Model?
 HV, U & Ek vs Period - Rigid Half-Space
 $Vs = 60 \text{ m/s}$, $h = 30 \text{ m}$, $v_L = 0.25$, $\lambda_L = 1000$

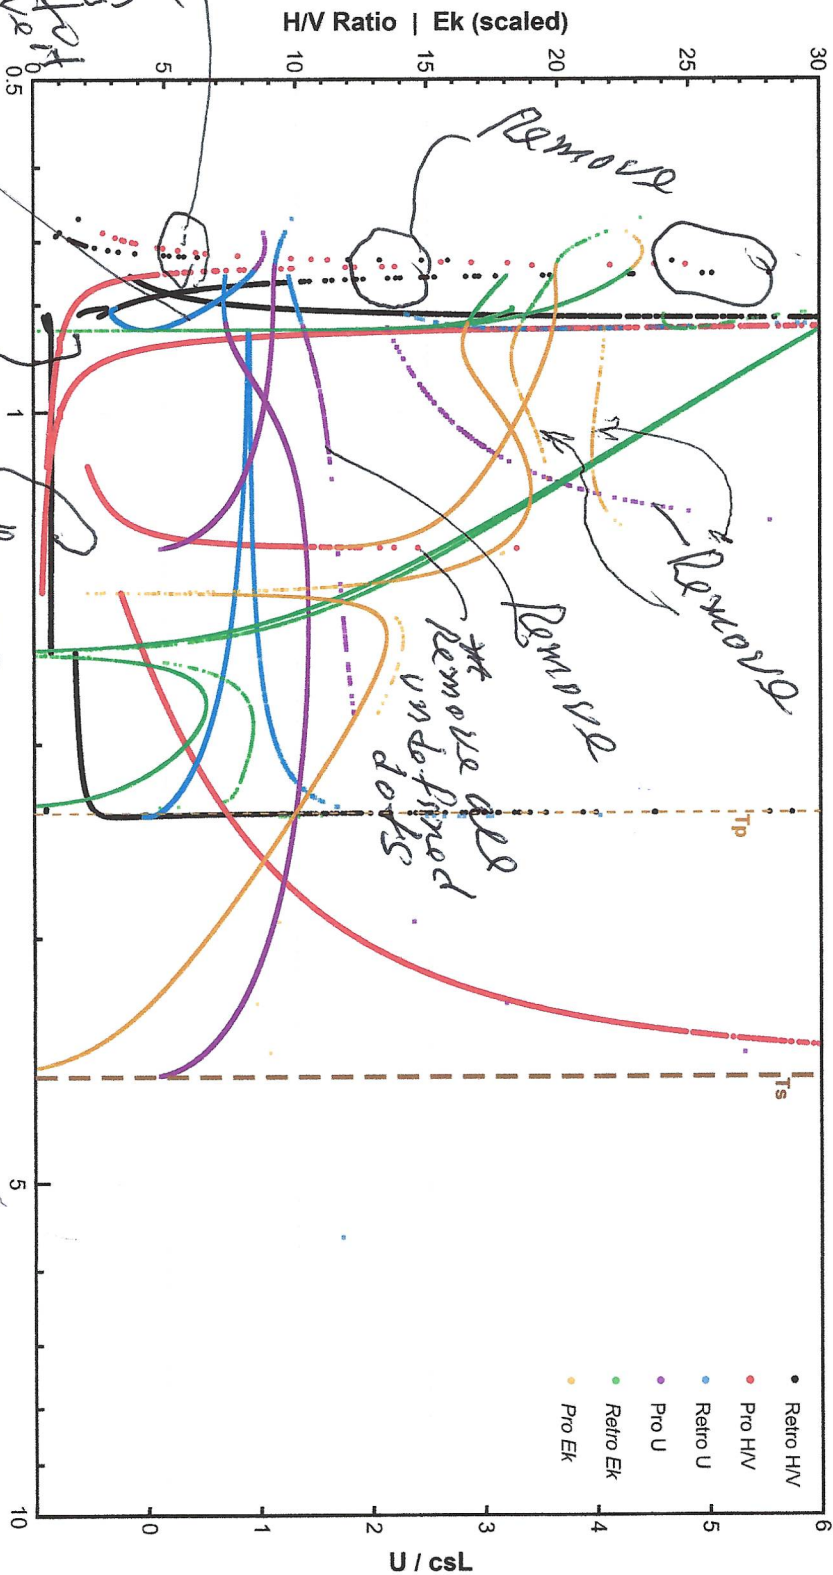
We will create a table in the paper. like this

Model	Vs	h	v	p
1	50	30	0.25	?
2	200	30	0.25	?
3	450	30	0.25	?

This is another model, but it's better for remove

What is this vertical line?
 It cannot be the
 However you are using the same color

How do you get this?
 I need the mb (notebook)
 documenting this
